REF.	DESCRIPTION.	DATE.
A	Precast Concrete kerbs replaced with Marshalls Kerbs (10' MB & 85 RM)	28.07.05

CLIENT:
Broadgate Homes Ltd

TITLE:
Lincolnshire County Council
Block Paved Constuction Minor Road and Footway Sections

NOTE:
THE SPECIFICATION SHALL IN ALL RESPECTS BE TO THE CURRENT DEVELOPMENT ROAD LAYOUT
GUIDE AND SPECIFICATION IN FORCE IN THE COUNTY AT THE TIME OF CONSTRUCTION.

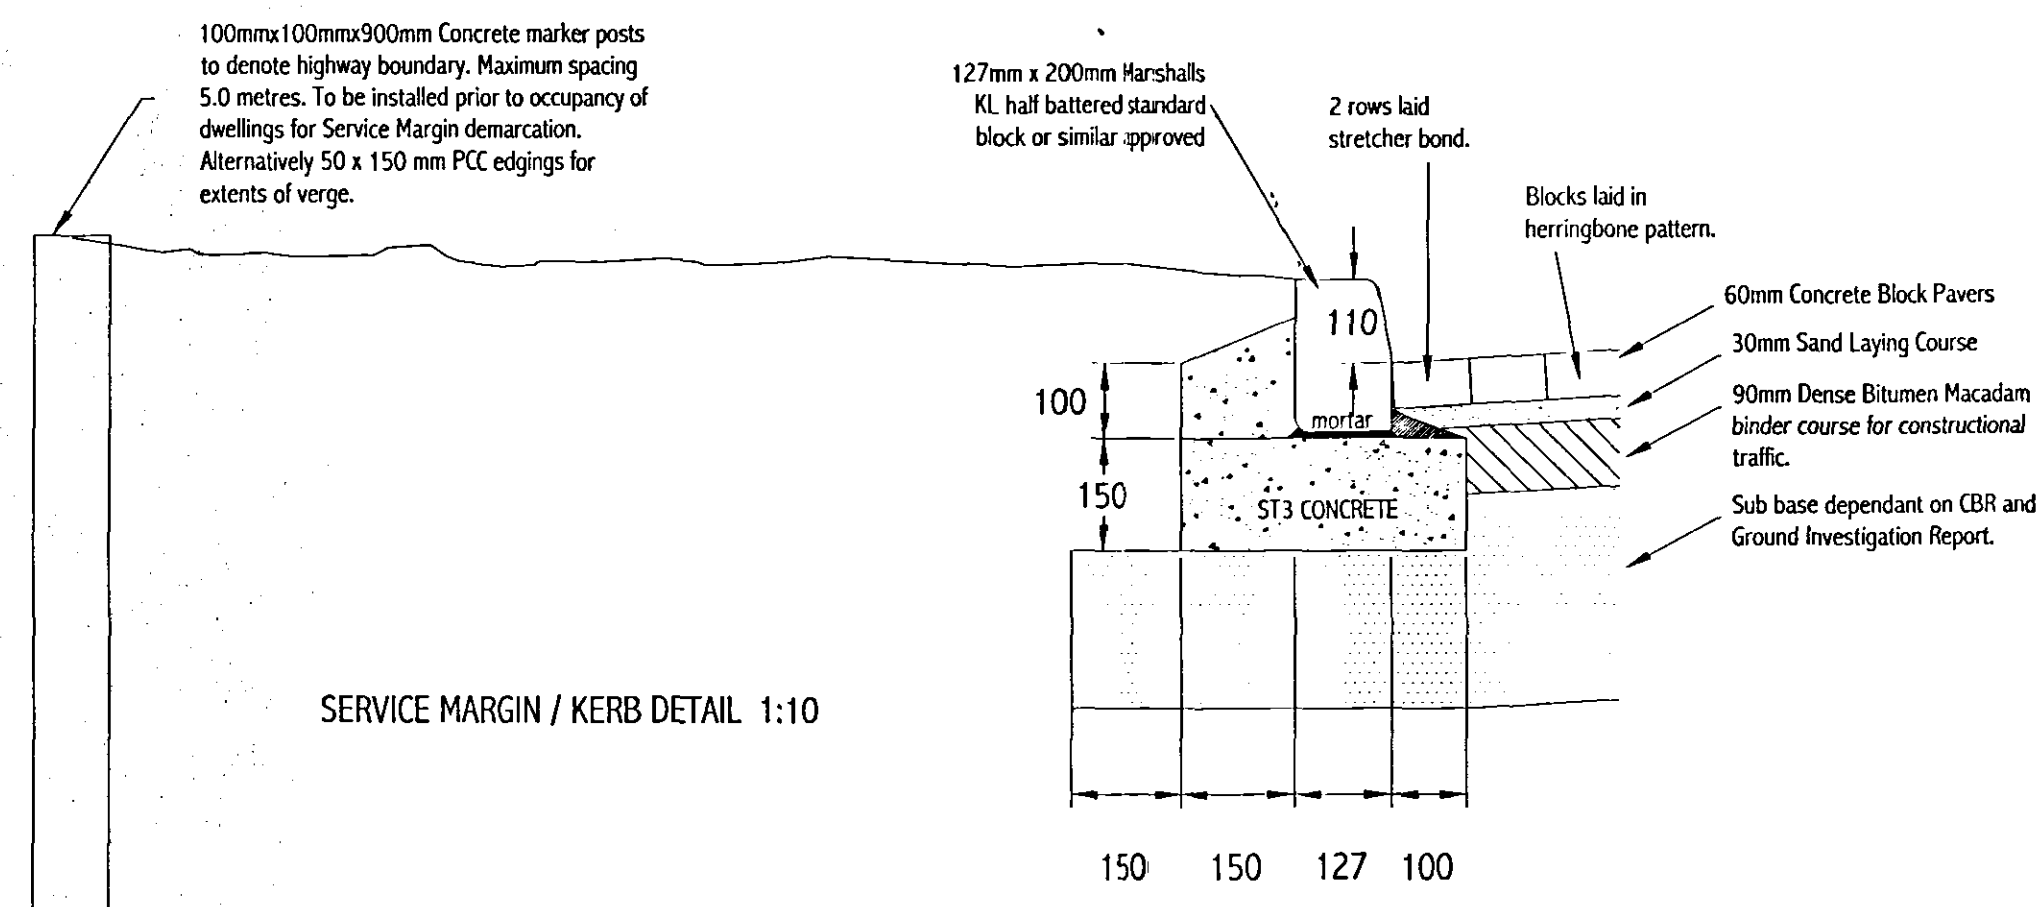
PRECAST CONCRETE UNIT KERBS ARE NOT TO BE USED
AND SHOULD BE REPLACED WITH MARSHALLS KL HALF
BATTERED STANDARD BLOCK OR KS BULL NOSED
STANDARD BLOCK OR SIMILAR APPROVED AS AGREED
AND INSTRUCTED BY DEAN WHITEHEAD OF
LINCOLNSHIRE COUNTY COUNCIL 27.07.05
